COMMONWEALTH OF VIRGINIA
COUNTY OF HENRICO

RE: POD2022-00192
SUB2022-00062
Sadler Crest
Site Plan (w/Notice)
Final Subdivision
Original Plan Review Comments II

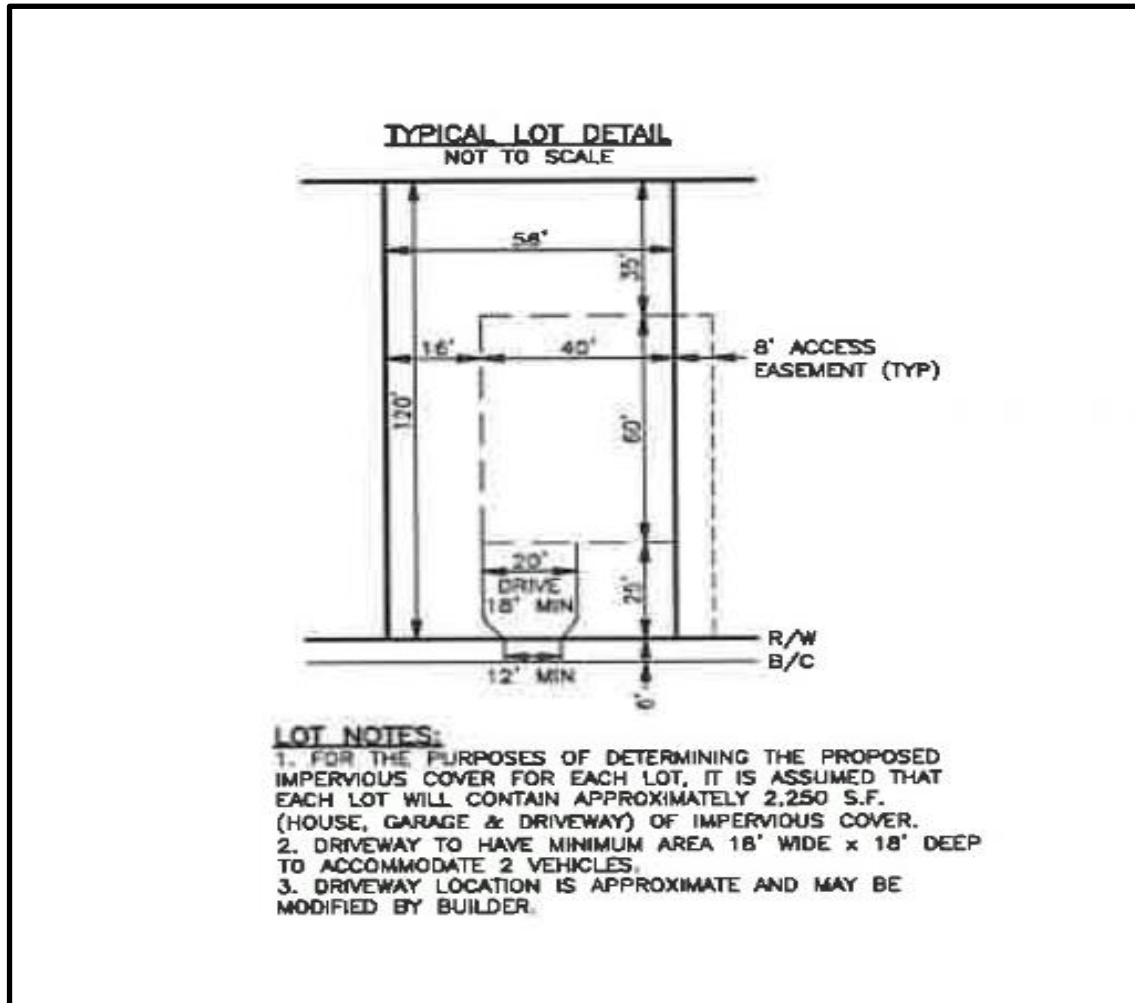
2. The lot lines for lot 10 and 19 need to be adjusted to meet the required 60' lot width.
 3. As previously stated, provide a *typical lot detail* similar to the below example. This is needed for a lot in the middle of a row of lots i.e. lot 6 and also for a corner lot i.e. lot 15, for a lot abutting common area, i.e. lot 1 and a lot at the end of a cul-de-sac i.e. lot 11.

- a. It will also need to contain similar lot notes and also address the landscaping requirements conceptually.
 4. Page C-4B
 5. Why is the LOD at the eastern property line? From looking at the grading sheet it does not appear that the LOD needs to be on this property line. It looks like the LOD against this property line can be adjusted so that the rear 35' can be preserved and the LOD adjusted to this general depth. This would enable proffer 3b to be met with existing vegetation which is always preferable to clear cutting and installing landscaping.
